**ADDENDUM NO. 2
INVITATION FOR BIDS**

Pickens Patterson Terrace Roof Replacement and Repair

Addendum Issue Date: February 23, 2010

SITE PLAN - PATTERSON TERRACE

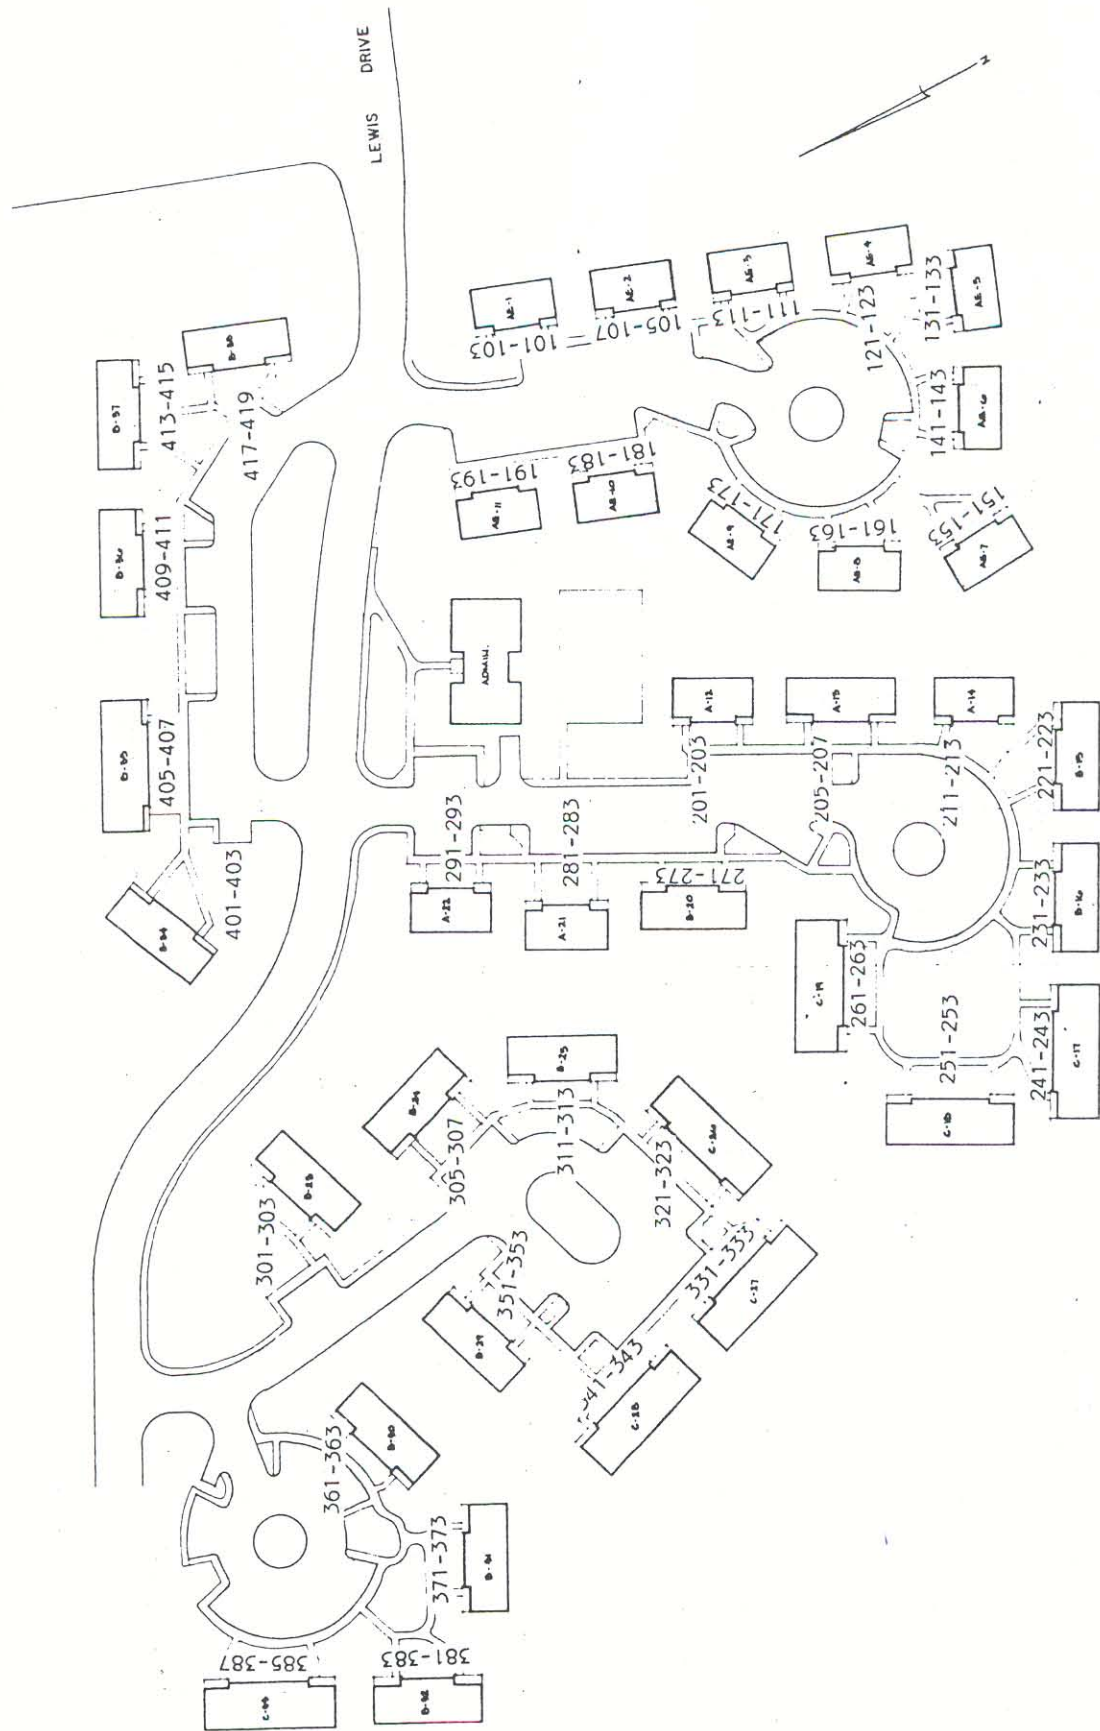
The site plan for Pickens Patterson Terrace is attached.

6. Q: I've reviewed the Bid documents on you (*sic*) web site for these 2 jobs you have out for bid. Do you have a site map of the buildings to be roofed at Patterson Terrace?

A: A site map of Pickens Patterson Terrace is provided as an attachment to this addendum. Plans/Blueprints are available for purchase at:
